JANUARY 6, 2021

## SUMMARY OF COMMUNITY OUTREACH

Response to Appeal of DRC approval decision for 15 Loma Alta AvenueResponse to Planning Commission Meeting on November 11<sup>th</sup> 2020Architecture and Site Application S-19-023

FRONT ELEVATION @ LOMA ALTA AVE.

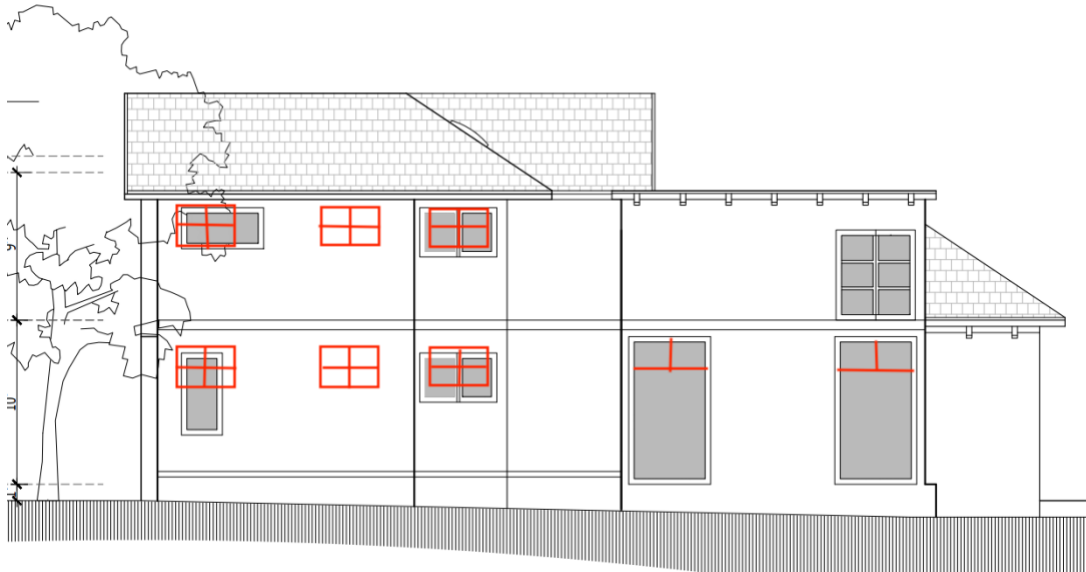
1. Consistent lighting on doors and windows: The color renderings (sheet 3.4) has consistent lighting (preferred) on the Front and Panighetti Place elevation, while the line drawings (sheet A3.1a) do not (redlines capture the renderings)

The facades in new plan set include all of these recommendations.

SIDE ELEVATION

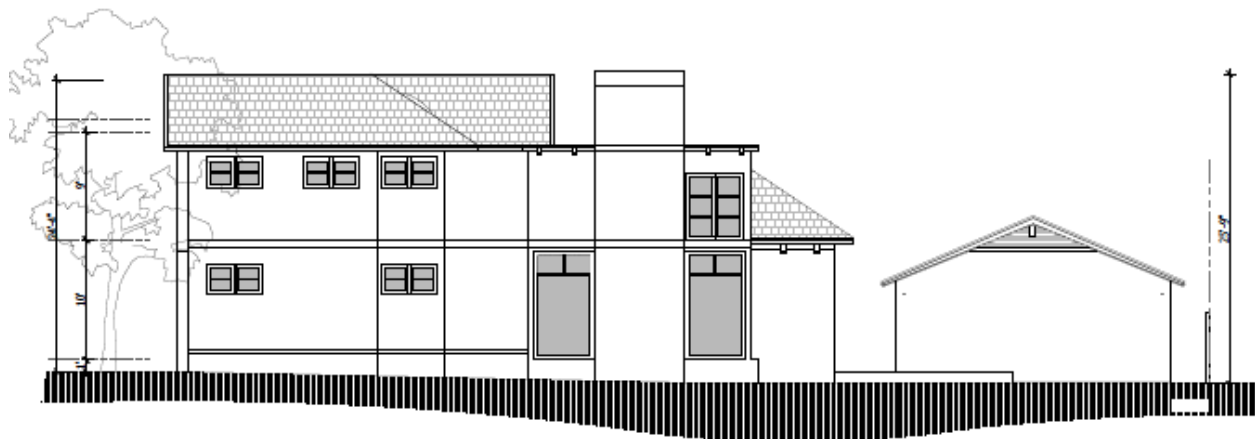
2. Sheet A3.1a calls out a Plexiglass railing – I believe this is a remanent of the prior design and should be eliminate for the exterior elevations.  
*Is removed in the new set.*
3. The Side Elevation fenestration is awkward and inconsistent with the Craftsman motif. A more consistent fenestration would be a multi-lighted high awning window to provide light and privacy to the two bedrooms and bathrooms. Further, some level of Craftsman lighting details at the top of the large view windows would tie them into the overall design.

4. There are inconsistencies between the floor plans and elevations. As example - the floor plan (living room) and front elevation shows a chimney, but the chimney is not shown on the side elevation.  
[Is addressed in the new plan set.](#)
5. The sloped roof overhangs are inconsistent depth. The Side Elevation overhang is much larger (2'10" from the roof plan or greater based on wall articulation) than any other overhang and appears quite awkward.  
[They are consistent now.](#)

The side elevation in the new plan set include all of these recommendations, except the additional window in first floor bedroom. It goes to the closet of that room.
